Service Bulletin

Bulletin No.: PI0885

Subject: Inoperative Heated Steering Wheel Operation after Replacing Steering Wheel

Models: 2012 Cadillac SRX

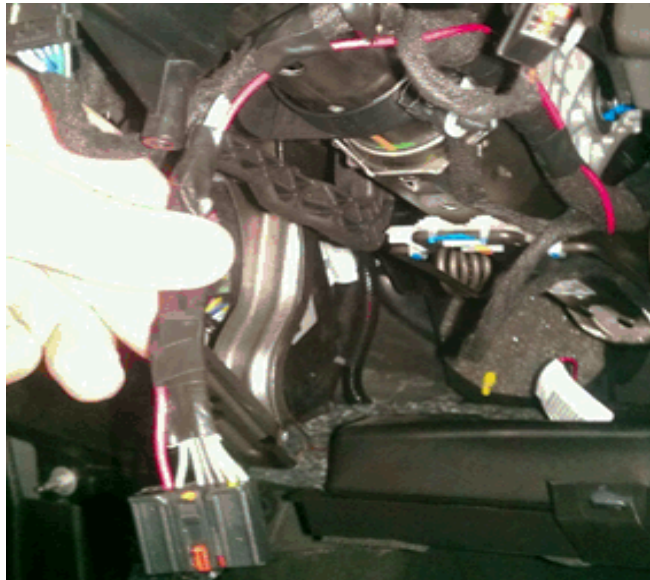
This condition may be caused by the illumination dimming circuit that is required with the replacement steering wheel that the original steering wheel did not utilize.

Add a new dimming circuit from the steering column air bag connector X1 and route and splice to connector X211 following the procedure below.

Note: 23 gauge wire being spliced to purple/white wire on connector X211 as shown in illustration above.

Note: 23 gauge wire routed to connector X1 with new wire in terminal cavity 8 as shown in illustration above.

3. Using 23 gauge wire, splice the wires together with the purple/white wire from connector X211 and route to connector X1 terminal cavity 8 as shown in the illustrations above.
4. Reinstall the left side front floor console extension.
5. Reinstall the driver knee bolster panel.
